Amendments to the Drawings

Fig. 1

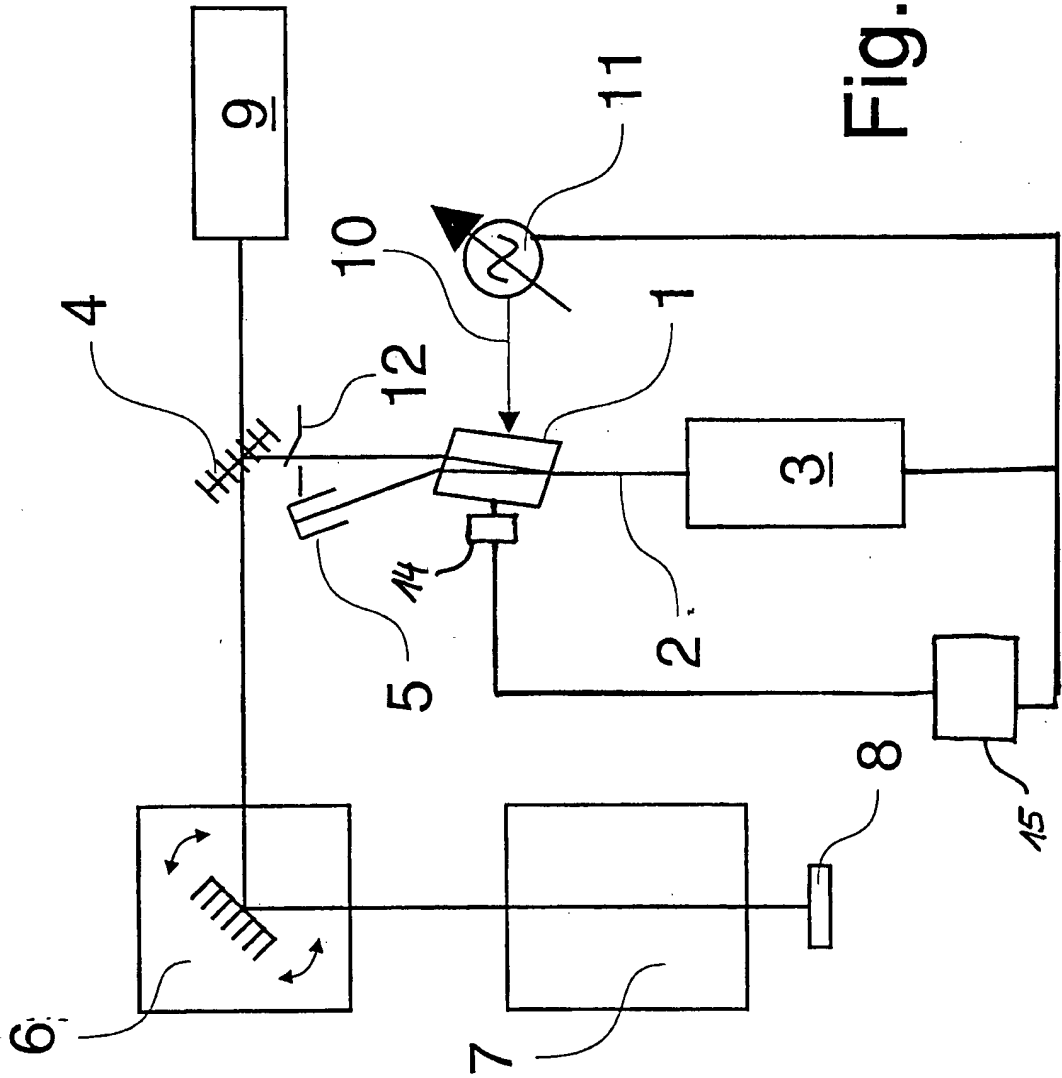
Applicant has amended the drawings to illustrate optional temperature sensor 14 proximate the optically active element. Attached herewith is a clean copy of the proposed amended drawing as well as a marked up version to illustrate the changes (shown in red).
